# Access Compliance Report

### (Curb Ramps)

Intersection ID: 7876	Main Street: BROOKTREE_DR	Cross Street: N/A	Location: SE
ADA ID: 71BBE5F52113	Ramp Type: BlendTrans2	Initial Pass/Fail: Fail	Overall Compliance: No
		Severity Score: 8.75	
Codes/Mitigation Info/Possible Solution		Field Measurements/Component Compliance

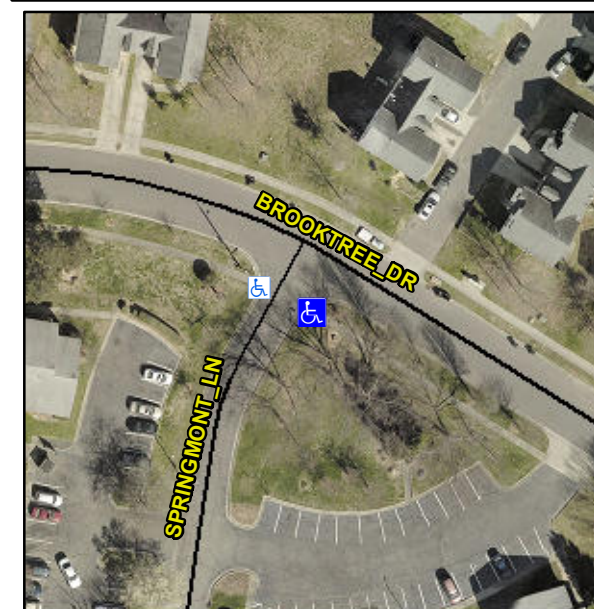
Compliance	Description	Data	Compliance	Description	Data
N/A	Ramp Length (in)	41.0	Yes	BlendTrans Slope (%)	2.1
No	Ramp Width (in)	47.5	Yes	BlendTrans XSlope (%)	1.9
N/A	Flare Type LT	N/A	N/A	Flare Type RT	N/A
N/A	Flare Slope LT (%)	N/A	N/A	Flare Slope RT (%)	N/A
N/A	Flare Traversable LT?	N/A	N/A	Flare Traversable RT?	N/A
N/A	Landing Length (in)	N/A	N/A	DWS Provided?	N/A
N/A	Landing Width (in)	N/A	N/A	DWS Contrast?	N/A
N/A	Landing Slope (%)	N/A	N/A	DWS Length (in)	N/A
N/A	Landing X Slope (%)	N/A	N/A	DWS Full Width?	N/A
N/A	Landing Curb? (Y/N)	N/A	N/A	DWS Offset (in)	N/A
N/A	Shared Landing?	N/A			
N/A	Gutter Ponding?	N/A	N/A	Gutter Slope (%)	N/A
N/A	Gutter Lip Ht (in)	N/A	N/A	Gutter X Slope (%)	N/A
N/A	Painted X Walk1?	No	N/A	Painted X Walk2?	N/A
	X Walk 1 Direction	To NW		X Walk 2 Direction	N/A
	X Walk 1 Width (in)	N/A		X Walk 2 Width (in)	N/A
	X Walk 1 Slope (%)	7.3		X Walk 2 Slope (%)	N/A
	X Walk 1 X Slope (%)	3.8		X Walk 2 X Slope (%)	N/A

**Remove & Replace Curb Ramp With Two New Directional Ramps or Equivalent.**

**R304.5.1**
